White Flint Metro Access Improvements, Mandatory Referral, MR2021032

Staff Recommendation: Approval with Comments

Staff recommends **approval** of this Mandatory Referral with the following comments:

Figure 12: Plan View – Rockville Pike (MD 355) at Old Georgetown Road

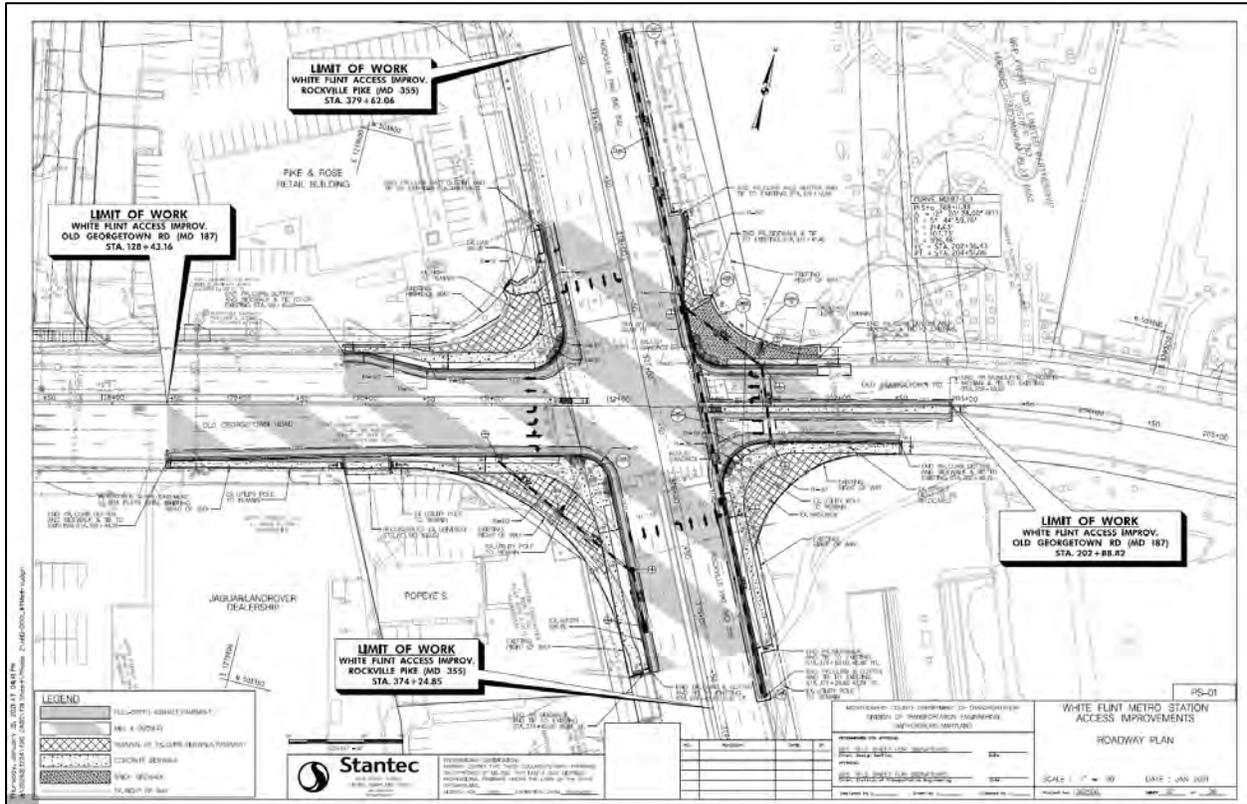
1. For all sidewalk work, crosswalks at driveways should be at sidewalk level.
2. Consider posting "No Turn on Red" on all intersection approaches at the Rockville Pike/Old Georgetown Road intersection.

4. Consider paving treatments in the NE, NW and SW corners of the Rockville Pike/Old Georgetown Road intersection to provide larger pedestrian circulation areas, potentially with plantings and amenities.

Intersection Improvements: With the proposed improvements, the intersection of Rockville Pike with Old Georgetown Road will be significantly more pedestrian-friendly, more urban in layout and provide a sense of place, while still providing significant traffic capacity. There are ways to improve on this design from both a safety and aesthetic perspective. First, as an intersection close to Metro and the Pike and Rose development, pedestrian crossings should be as safe as possible, and therefore right turns should be prohibited on red lights and “No Turn on Red” signs should be posted for all approaches of this intersection.

From the aesthetic side, this does seem to be an opportunity to make the intersection corners more attractive and functional, with the use of paving treatments and planters and pedestrian amenities consistent with current and developing streetscape guidelines in the White Flint/Pike District area. Currently, the design of these corners is very utilitarian. This is an opportunity that should not be lost.

Figure 24: Rockville Pike/Old Georgetown Road Intersection – Potential Sidewalk Improvement

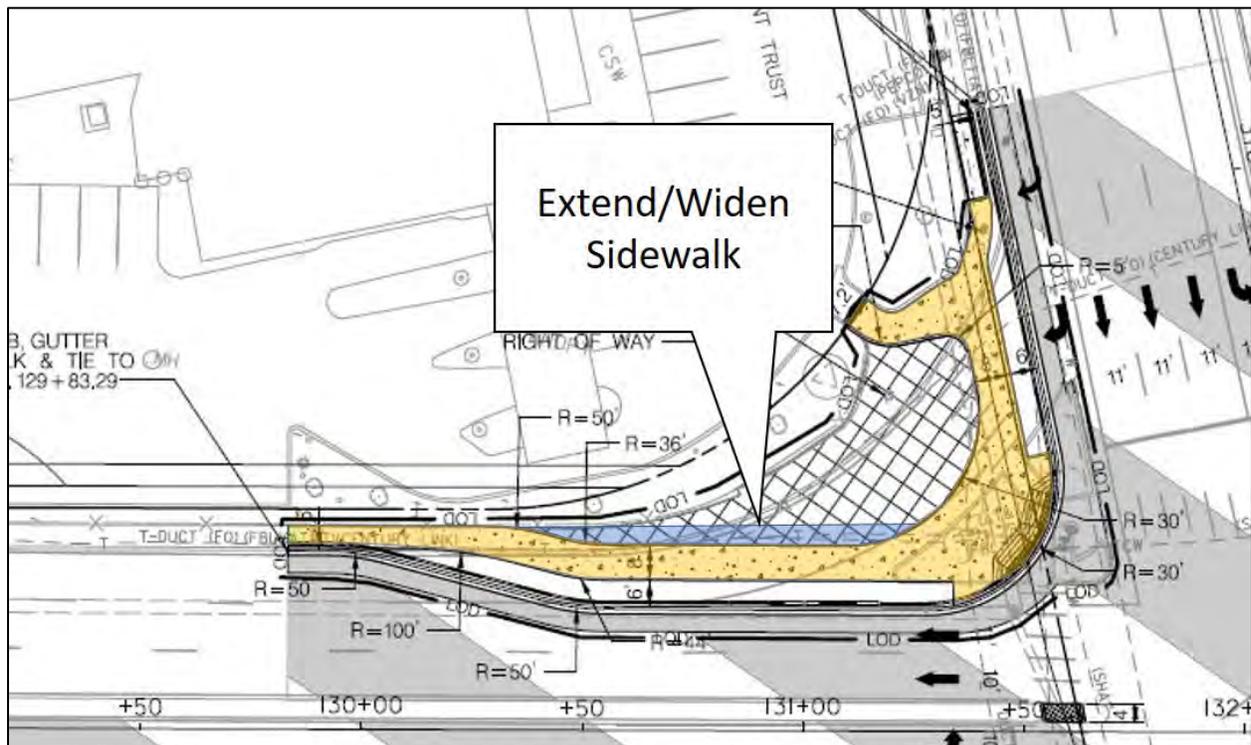
3. In the NW corner of the Rockville Pike/Old Georgetown Road intersection, extend the existing sidewalk on Old Georgetown Road in a straight line approaching the intersection. Do not bend the sidewalk closer to the curb by 6 feet as shown. Provide a wider sidewalk in the curb extension section near the corner and maintain a 6-foot wide grass buffer.

There is also a sidewalk layout issue on Old Georgetown Road in the northwest corner as shown below in Figure 24. The proposed sidewalk (shown in yellow shading) leaves the intersection heading west and then does a jog or shift to the north to connect to the existing sidewalk. Staff recommends eliminating the jog and extending the sidewalk directly toward the intersection corner as highlighted in blue shading in the graphic. This has an added benefit of widening the sidewalk in this location.

LANDSCAPE PLAN

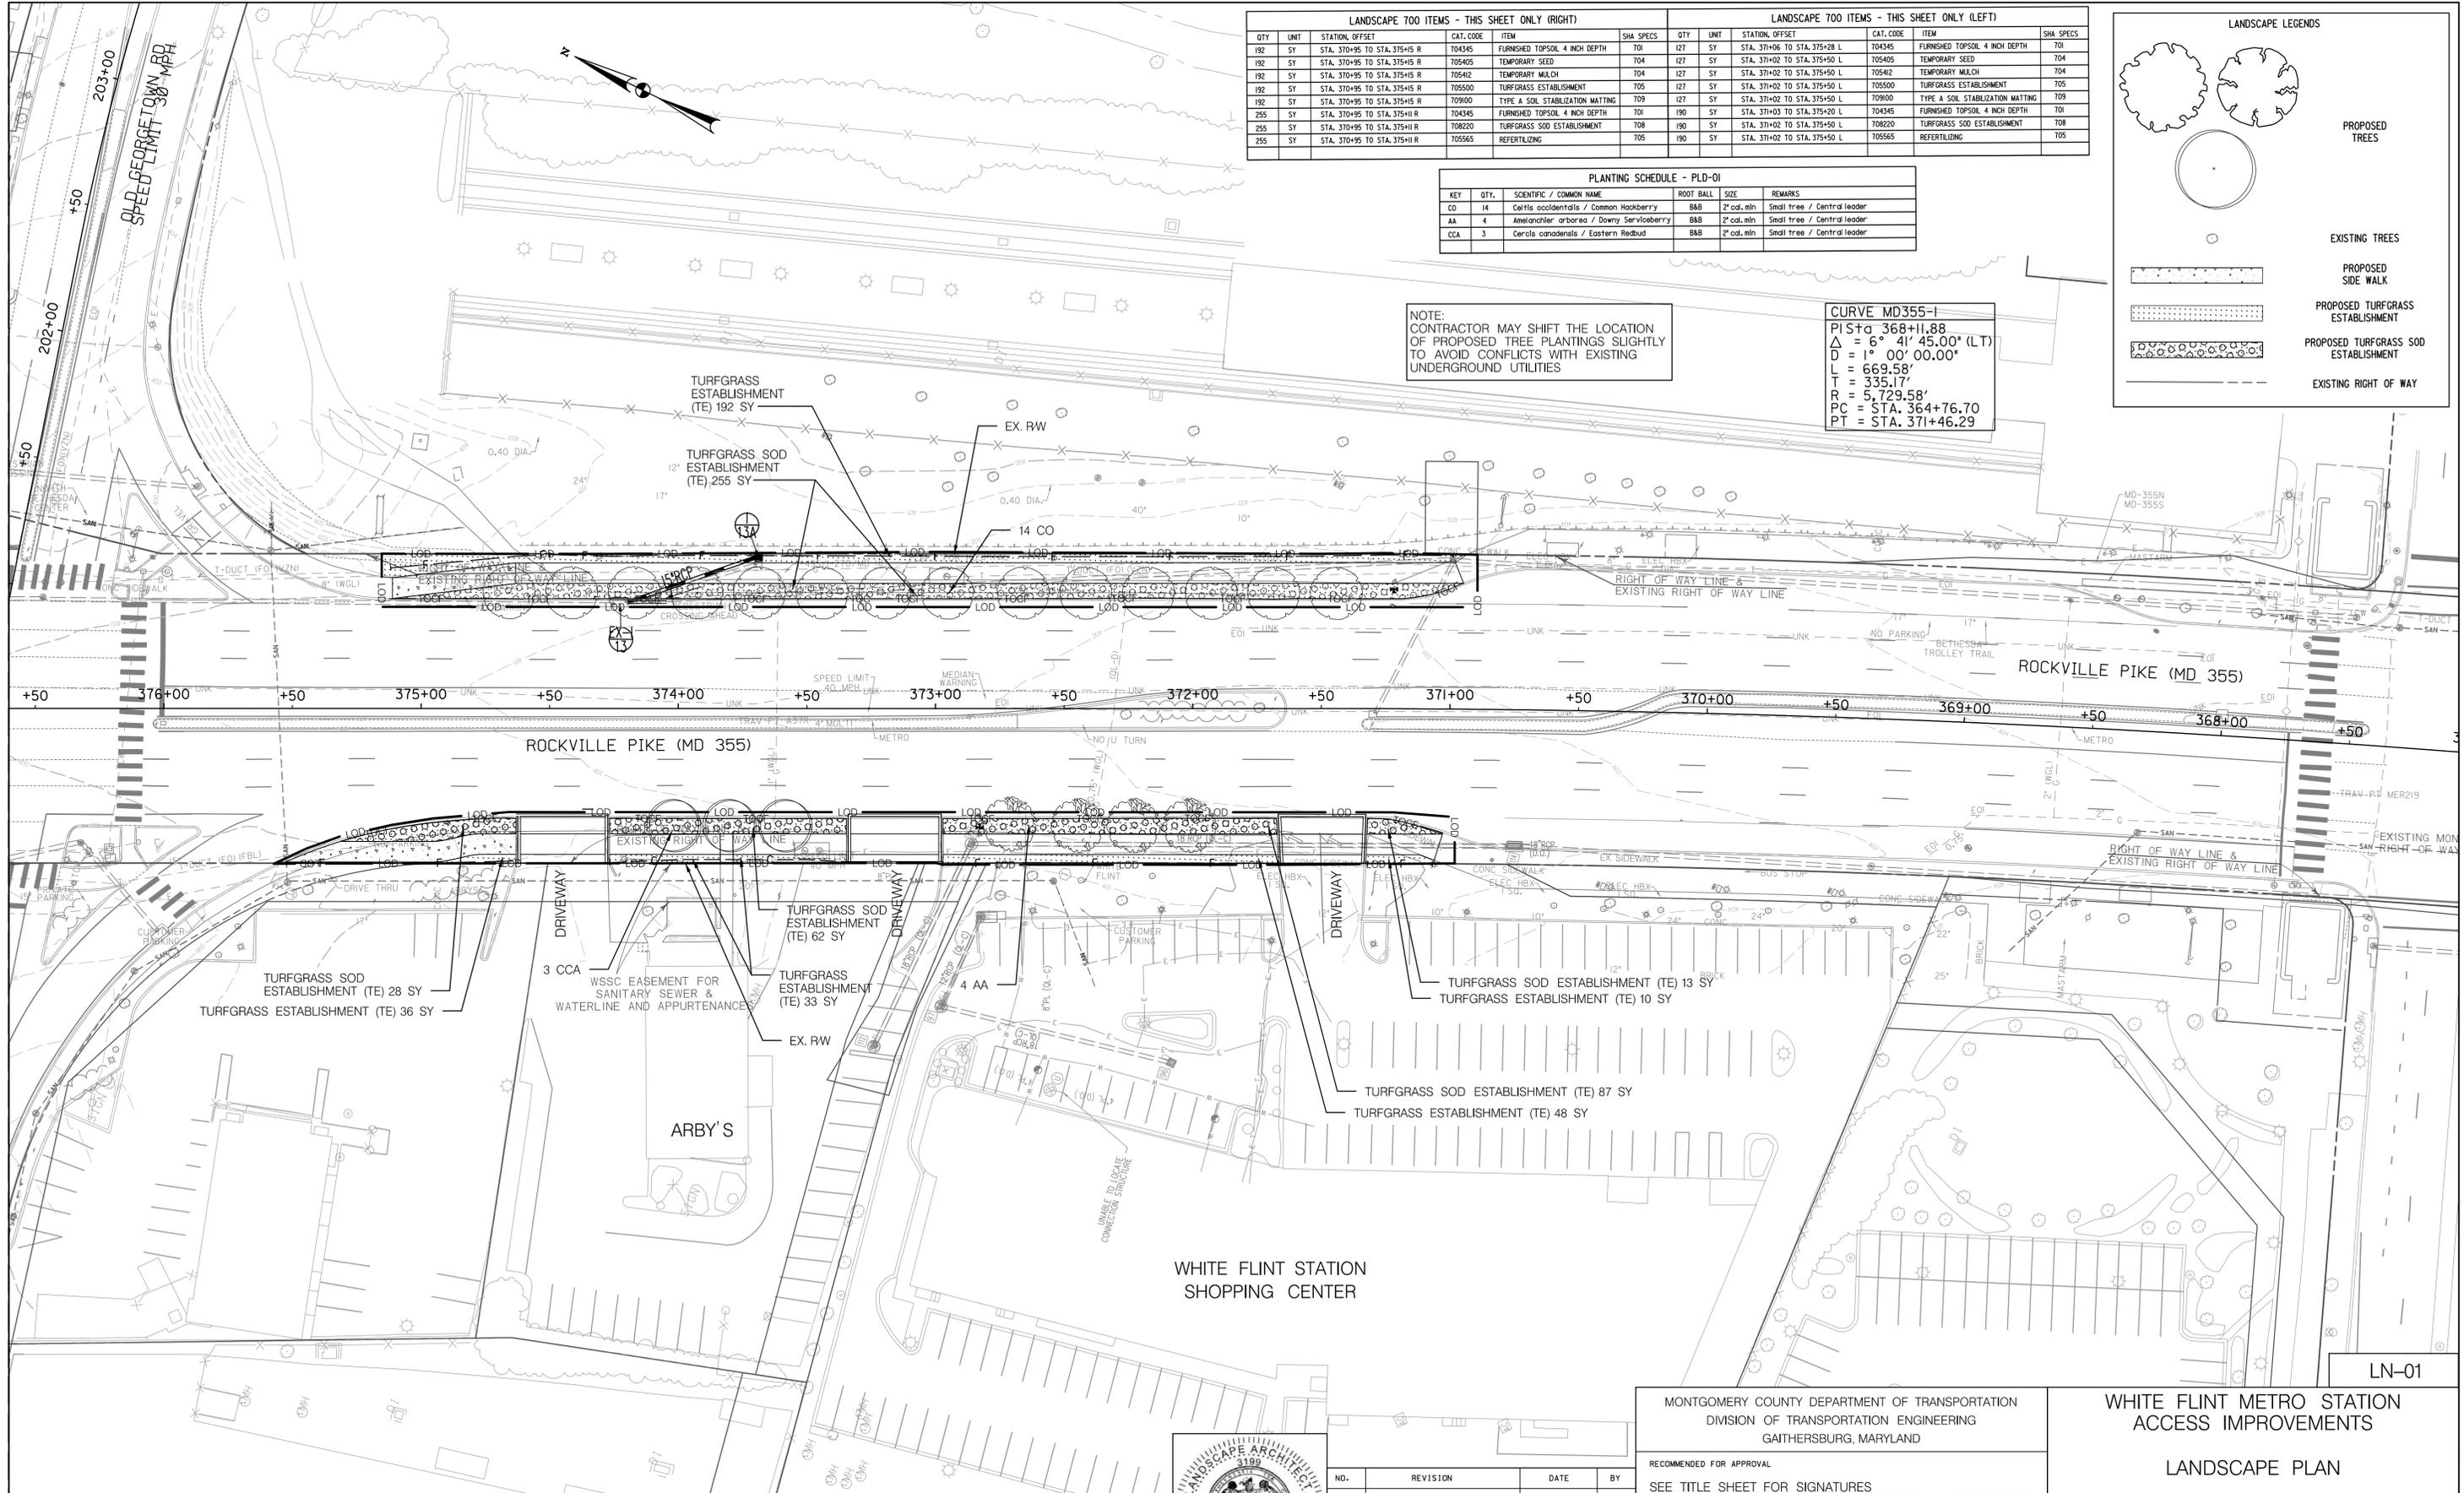
Staff recommends that the Landscape Plan replace the Chinese elm trees with one of the new variants of American elm that are resistant to Dutch elm disease, or with another suitable native tree species.
